BURRIS/WAGNON ARCHITECTS, P.A.

ADDENDUM NO. 2

Re: **Batson Finishes 3rd Floor**
University of Mississippi Medical Center
Jackson, MS
IHL #209-585

BATSON - THIRD FLOOR PLAN - HVAC
SCALE: 1/8" = 1'-0"

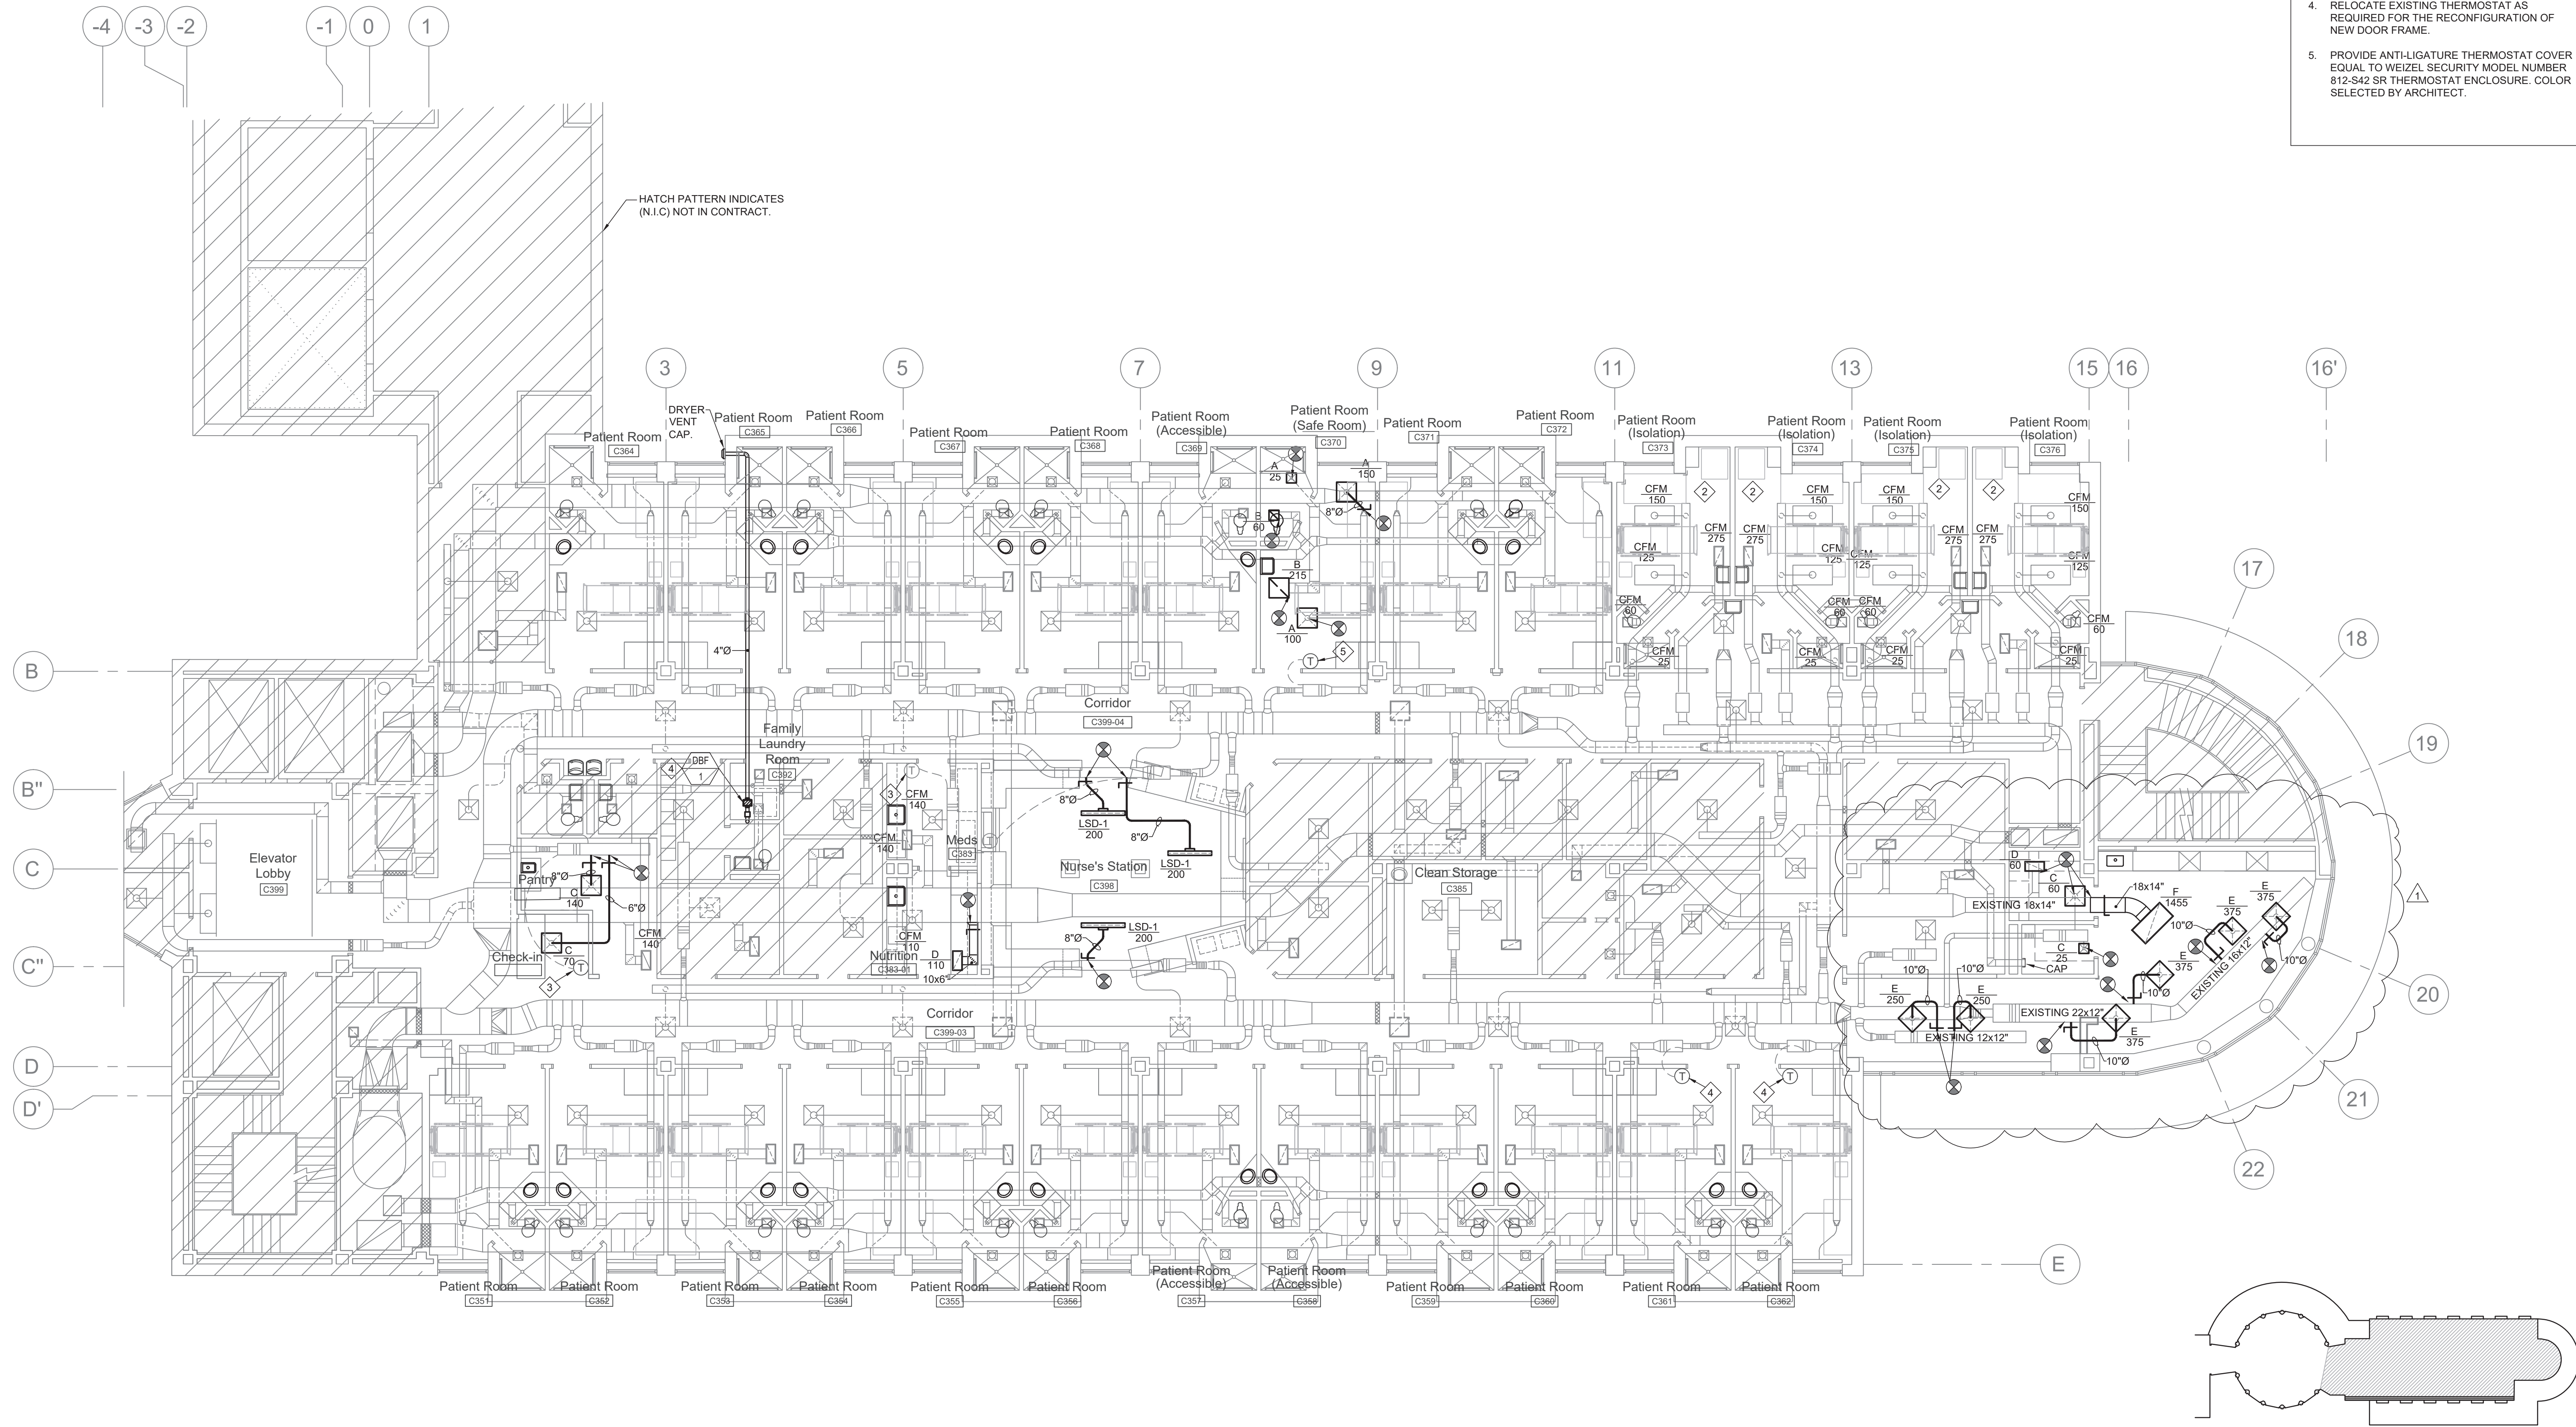
- PLAN NOTES:**
- 4" DRYER EXHAUST DUCT UP IN WALL TO CEILING. CONNECT TO LINT TRAP AND DRYER BOOSTER FAN AND CONTINUE EXTERIOR WALL. PROVIDE DRYER VENT CAP SEIHO SFB-P OR EQUAL. SEE DETAIL FOR LINT TRAP LOCATION. DRYER VENT TO BE PROVIDED AND INSTALLED IN STRICT ACCORDANCE WITH 2015 IMC 504.8.4.1 THRU 504.8.5.
 - CONTRACTOR SHALL RESET CONTROLS FOR PATIENT ISOLATIONS ROOM TO BE NEGATIVE TO CORRIDOR. CFM OF GRILLES SHOWN ON PLANS.
 - RELOCATED THERMOSTAT LOCATION.
 - RELOCATE EXISTING THERMOSTAT AS REQUIRED FOR THE RECONFIGURATION OF NEW DOOR FRAME.
 - PROVIDE ANTI-LIGATURE THERMOSTAT COVER EQUAL TO WEIZEL SECURITY MODEL NUMBER 812-S42 SR THERMOSTAT ENCLOSURE. COLOR SELECTED BY ARCHITECT.

ADDENDUM #2
CLOUD COMPRISES ALT. #2

BATSON - THIRD FLOOR PLAN - FIRE PROTECTION
 SCALE: 1/8" = 1'-0"

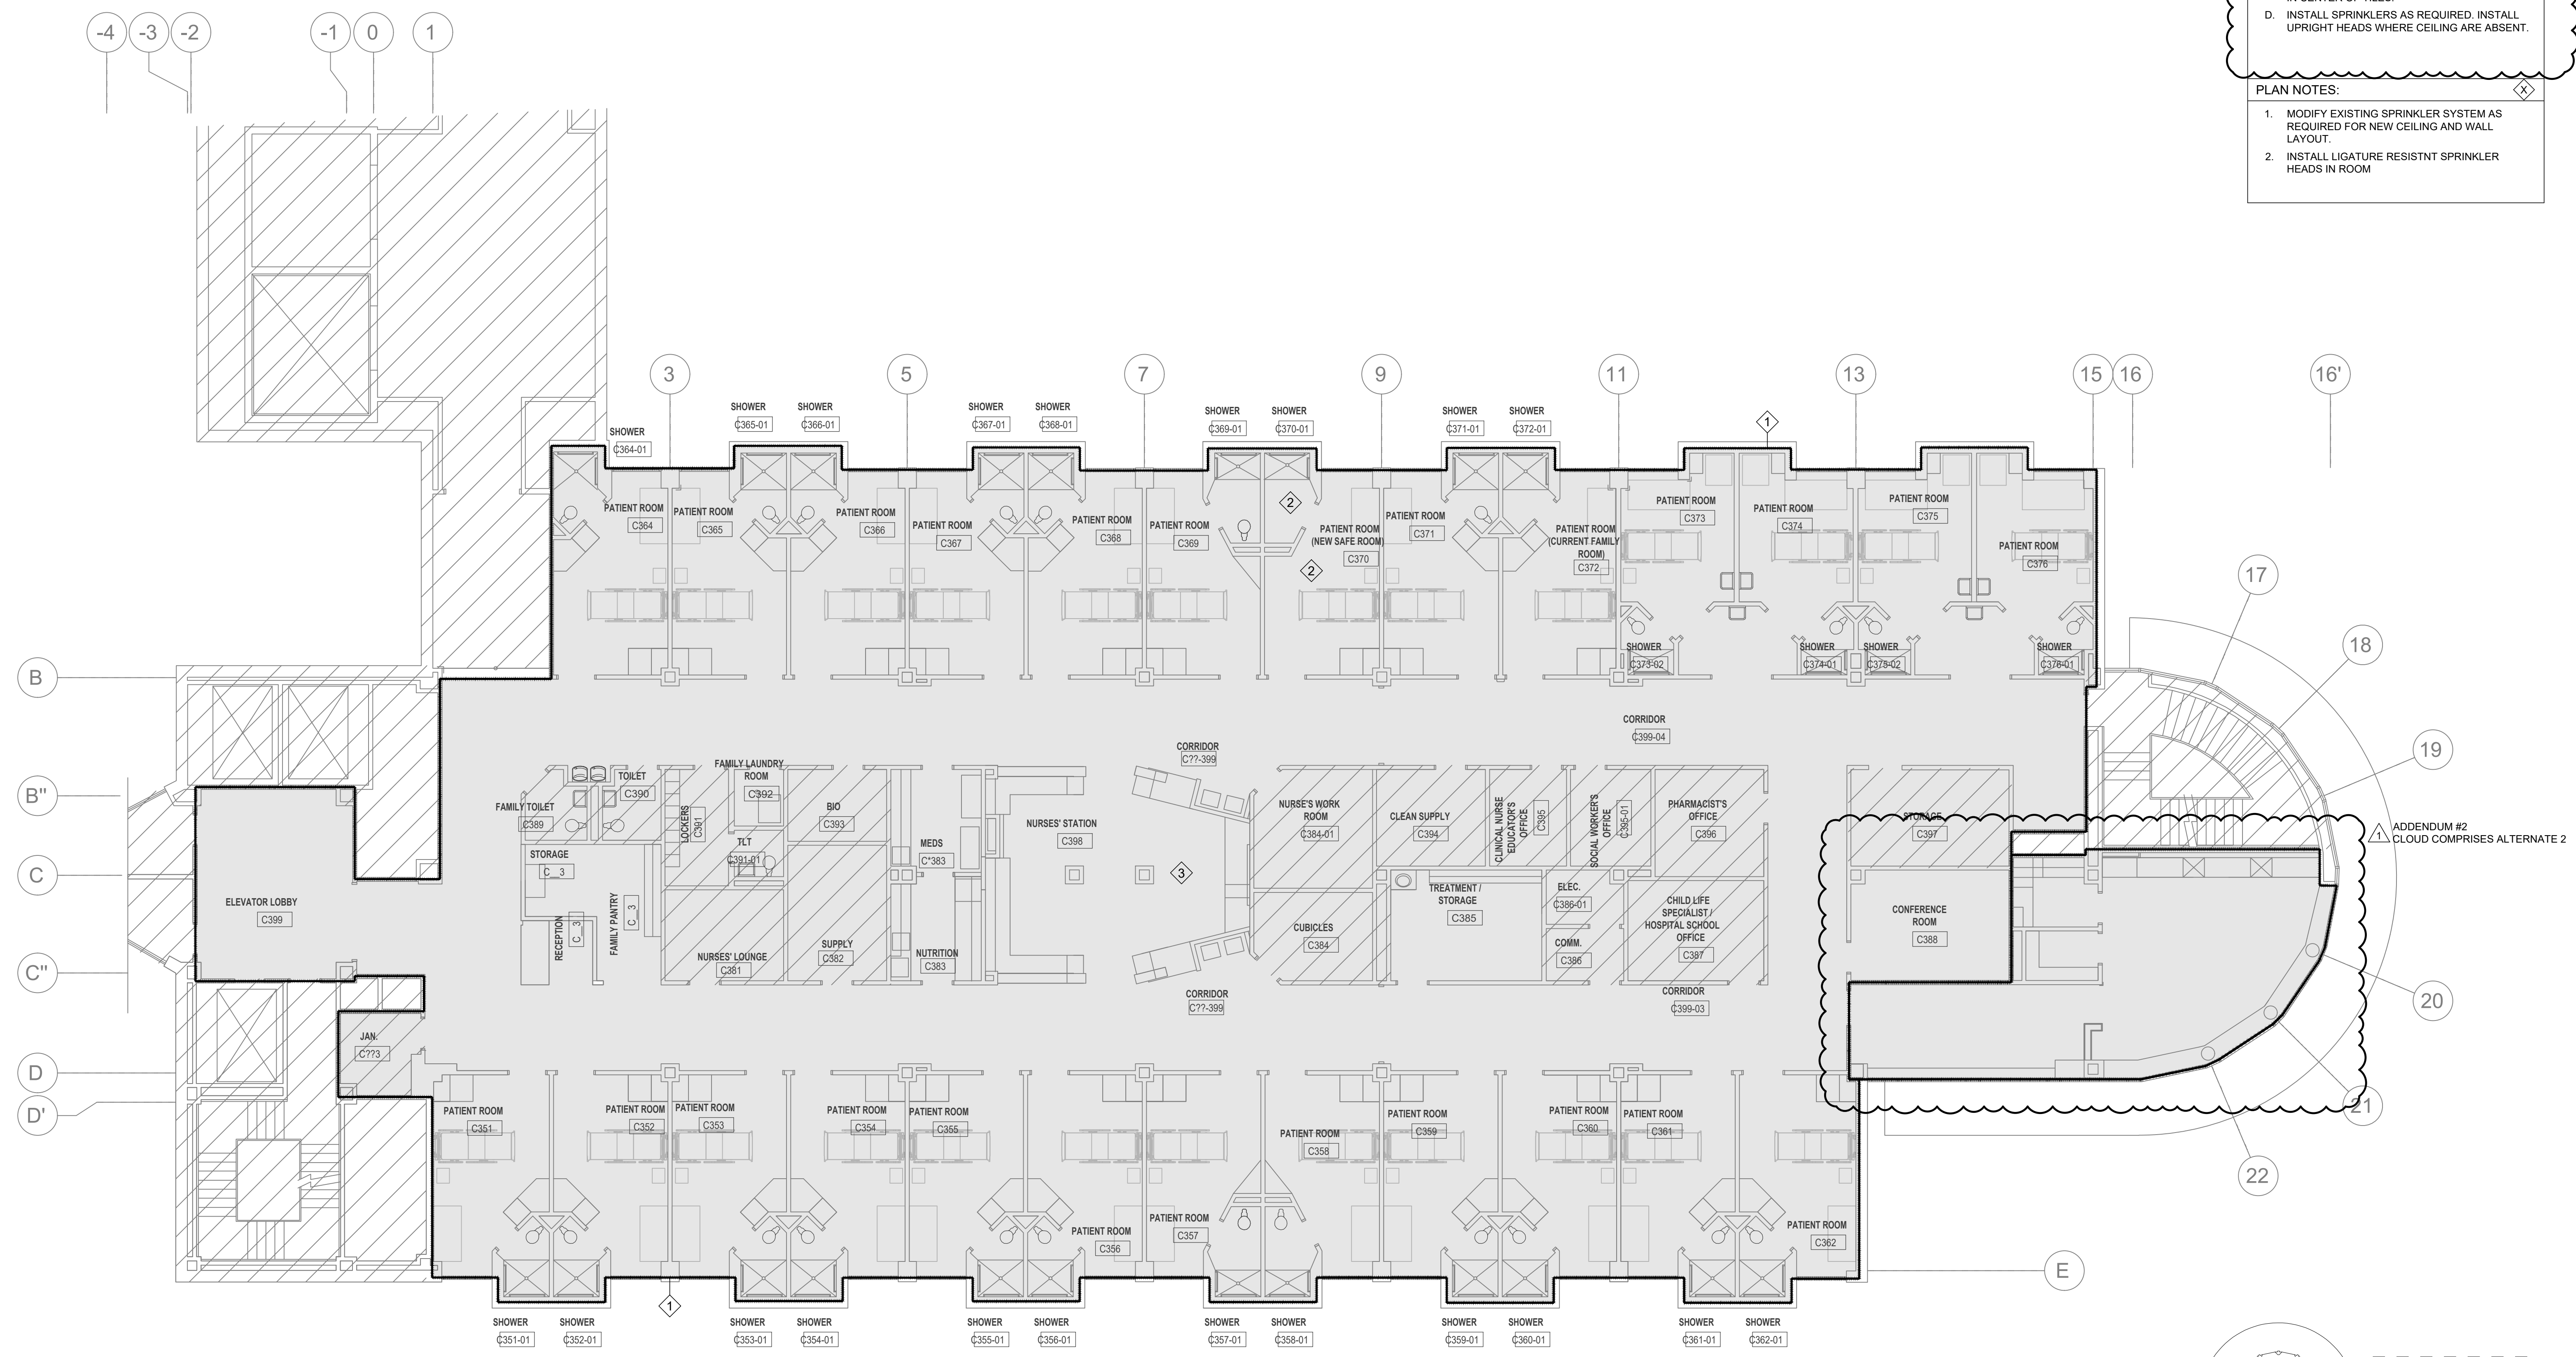
ADDENDUM #2
CLOUD COMPRISES ALT. #2

- GENERAL NOTES:**
- A. MODIFY EXISTING SPRINKLER SYSTEM IN ACCORDANCE WITH NFPA 13.
 - B. ALL NEW FLEXIBLE CONNECTORS SHALL BE BRAIDED STAINLESS STEEL TYPE.
 - C. NEW SPRINKLER HEADS SHALL BE INSTALLED IN CENTER OF TILES.
 - D. INSTALL SPRINKLERS AS REQUIRED. INSTALL UPRIGHT HEADS WHERE CEILING ARE ABSENT.
- PLAN NOTES:**
- 1. MODIFY EXISTING SPRINKLER SYSTEM AS REQUIRED FOR NEW CEILING AND WALL LAYOUT.
 - 2. INSTALL LIGATURE RESISTNT SPRINKLER HEADS IN ROOM

BATSON - THIRD FLOOR PLAN - PLUMBING DEMOLITION
SCALE: 1/8" = 1'-0"

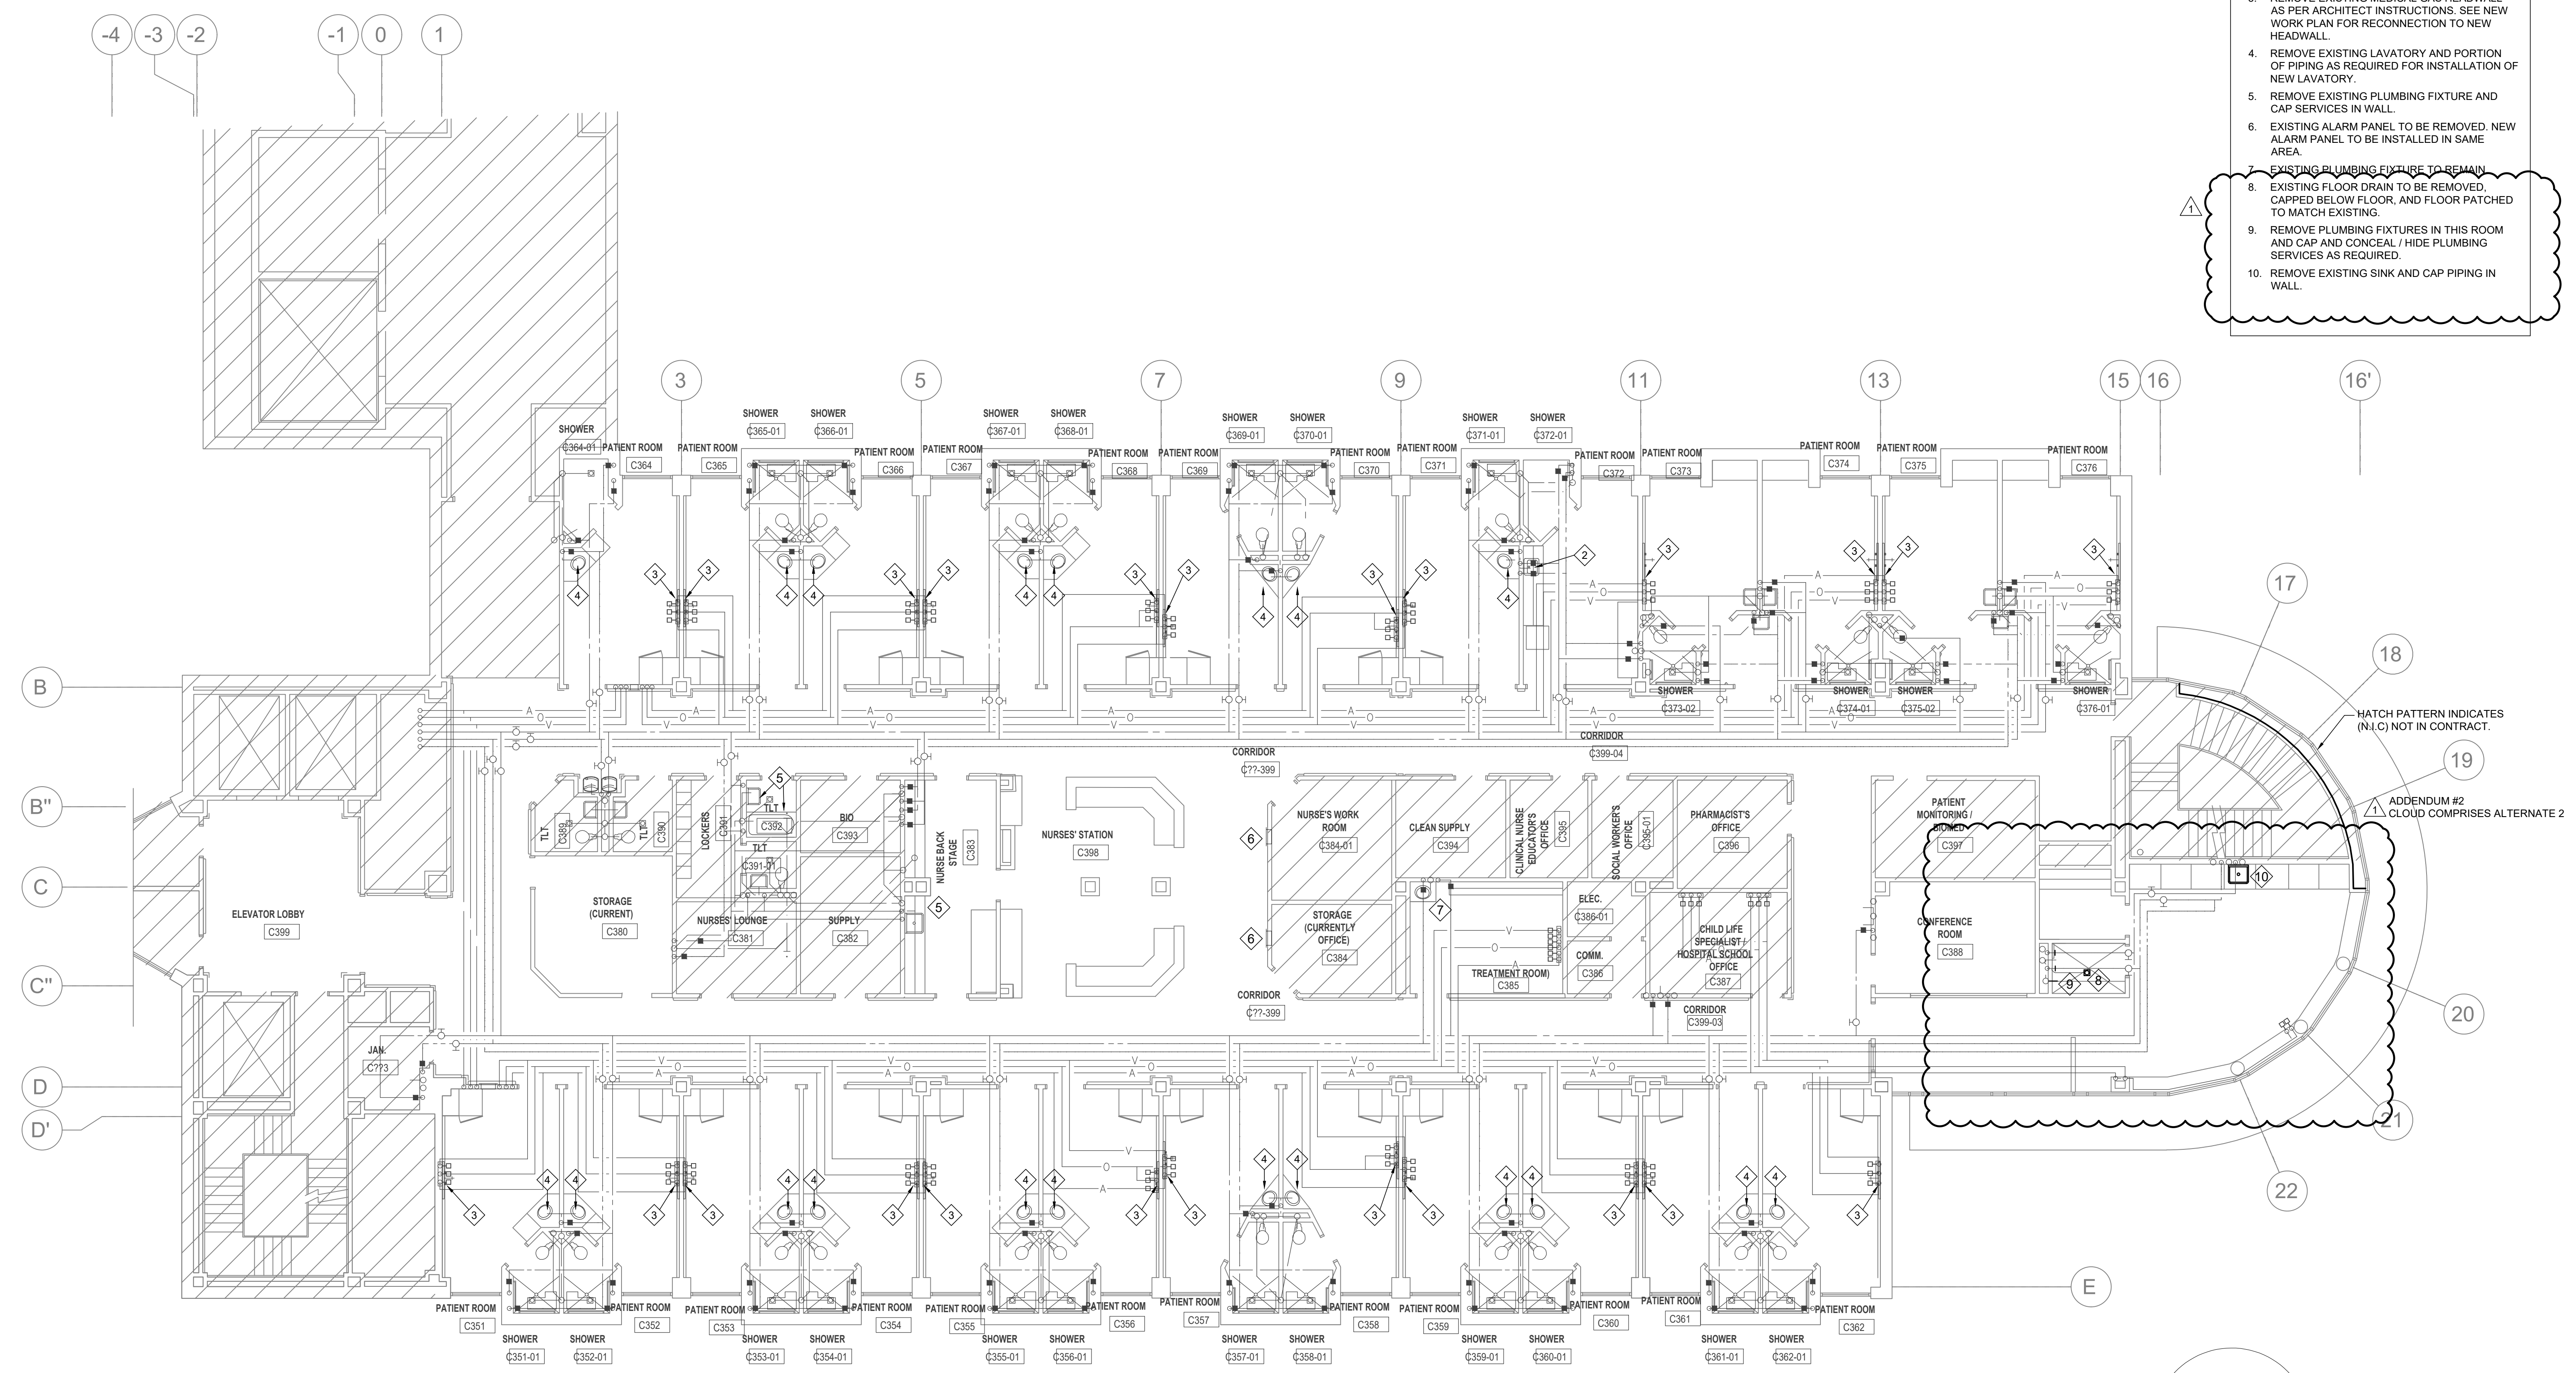
1. REMOVE EXISTING WASHING MACHINE BOX. CAP WASTE BELOW FLOOR AND VENT ABOVE CEILING. SEE NEW WORK PLAN FOR NEW CONNECTIONS TO SHOWER VALVE AND HEAD.

2. REMOVE EXISTING 2 COMPARTMENT STAINLESS STEEL SINK. SEE NEW WORK PLAN FOR RECONNECTION TO NEW LAVATORY INSTALLATION.
3. REMOVE EXISTING MEDICAL GAS HEADWALL AS PER ARCHITECT INSTRUCTIONS. SEE NEW WORK PLAN FOR RECONNECTION TO NEW HEADWALL.

4. REMOVE EXISTING LAVATORY AND PORTION OF PIPING AS REQUIRED FOR INSTALLATION OF NEW LAVATORY.
5. REMOVE EXISTING PLUMBING FIXTURE AND CAP SERVICES IN WALL.

6. EXISTING ALARM PANEL TO BE REMOVED. NEW ALARM PANEL TO BE INSTALLED IN SAME AREA.
7. EXISTING PLUMBING FIXTURE TO REMAIN.
8. EXISTING FLOOR DRAIN TO BE REMOVED, CAPPED BELOW FLOOR, AND FLOOR PATCHED TO MATCH EXISTING.

9. REMOVE PLUMBING FIXTURES IN THIS ROOM AND CAP AND CONCEAL / HIDE PLUMBING SERVICES AS REQUIRED.
10. REMOVE EXISTING SINK AND CAP PIPING IN WALL.

ADDENDUM #2 CLOUD COMPRISES ALTERNATE 2
